Well Name	Well Number	US Well Number	Lease Number	Case Number	Operator
RIO BLANCO 4-	103H	3002554247	NMNM92199	NMNM139078	DEVON
RIO BLANCO 4-	106H	3002554250	NMNM19142	NMNM140034	DEVON

Notice of Intent

Type of Action: APD Change

Procedure Description: Engineering Only - Devon Energy Production Company L.P. respectfully requests the following changes to the approved APD: Offline BOP/Stump testing variance request. Batched wells on Rio Blanco 4 Wellpad 5. No other requested changes to drilling program. Please see attached drill plan with offline cement verbiage and Break Test Variance_Offline BOP variance request document.

Section 2 - Blowout Preventer Testing Procedure

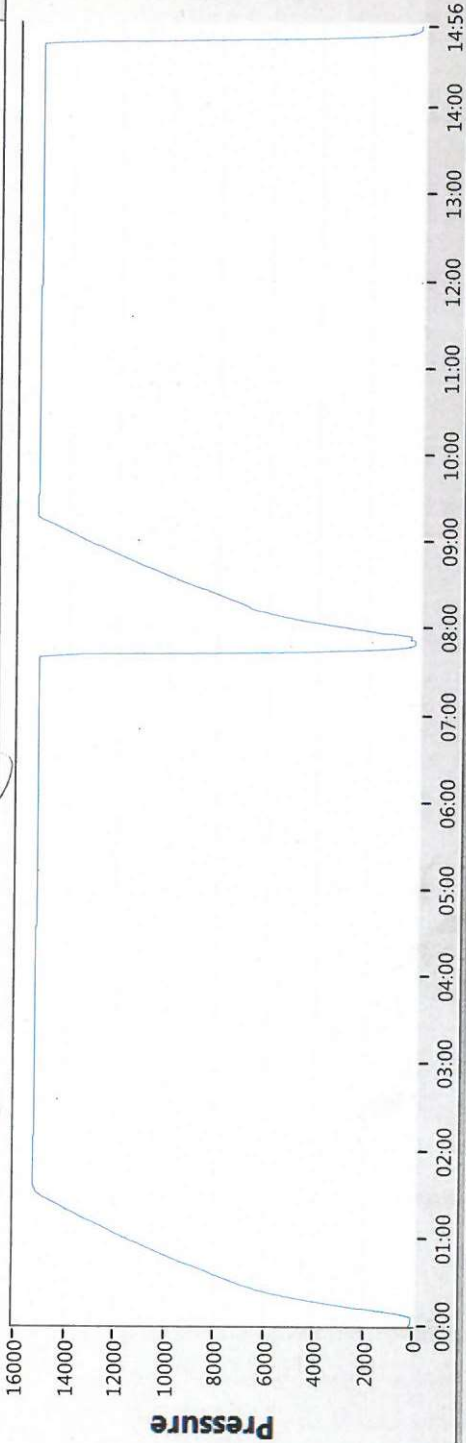
Devon Energy requests to only test BOP connection breaks after drilling out of surface casing and while skidding between wells which conforms to API Standard 53 and industry standards. The initial BOP test will follow 43 CFR 3172, and subsequent tests following a skid will only test connections that are broken. This test will at minimum include the Top Pipe Ram, HCR, Kill Line Check Valve, QDC (quick disconnect to wellhead) and BOP shell of the 10M BOPE to 5M for 10 minutes. Additional pressure testing is required for pressure-containing and pressure-controlling connections when the integrity of a pressure seal is broken. If a break to the flex hose that runs to the choke manifold is required due to repositioning from a skid, the HCR will remain open during the shell test to include that additional break. The variance only pertains to intermediate hole-sections. This variance will meet or exceed 43 CFR 3172 per the following: Devon Energy will perform a full BOP test per 43 CFR 3172 before drilling out of the intermediate casing string(s) and starting the production hole, testing the Annular during initial BOP testing to a minimum of 70% RWP and higher than MASP, and pressure testing at a 21-day interval frequency. The BLM will be contacted 4hrs prior to a BOPE test. The BLM will be notified if and when a well control event is encountered. In the event break testing is not utilized, then a full BOPE test would be conducted.

Devon Energy requests to perform offline BOP stump testing and offline BOPE testing. All pressure-containing and pressure-controlling seals will be tested either online or offline as denoted in the table below and per BLM approval during initial BOP test following test pressure requirements set forth in 43 CFR 3172. Remaining components not tested offline or on the stump will be tested within 72-hours when the BOP is connected to the wellhead. If stump testing exceeds 72-hour window prior to connecting to the wellhead, the BLM will be notified and either stump testing restarted, or the BOP being tested online. The BLM will be contacted 4hrs prior to a BOPE test. The BLM will be notified if and when a well control event is encountered. In the event stump testing is not utilized, then a full BOPE test would be conducted.

Devon requests offline BOPE testing for the following components: Upper Rams, Blind Rams, Kill Valves, Choke Valves, and Annular

Devon requests Break testing as stated above for SK tests, not including production hole

Annular Preventer will be tested to minimum of 70% RWP and higher than MASP during initial BOP test

Pressure testing is required for pressure-containing connections if the integrity of a pressure seal is broken during a break test

All Previous COAs Still Apply. Variance request procedure is approved as written, please see below general conditions for variance.

BOPE Break Testing Variance

- BOPE Break Testing is ONLY permitted for 5M BOPE or less. **(Annular preventer must be tested to a minimum of 70% of BOPE working pressure and shall be higher than the MASP)**

- BOPE Break Testing is NOT permitted to drilling the production hole section.
- Variance only pertains to the intermediate hole-sections and no deeper than the Bone Springs formation.

Operator has been **(Approved)** to test the BOPE offline.

Online BOPE testing should commence within 72 hours of offline BOPE testing completion. Notify the BLM if interval exceeds 72 hours.
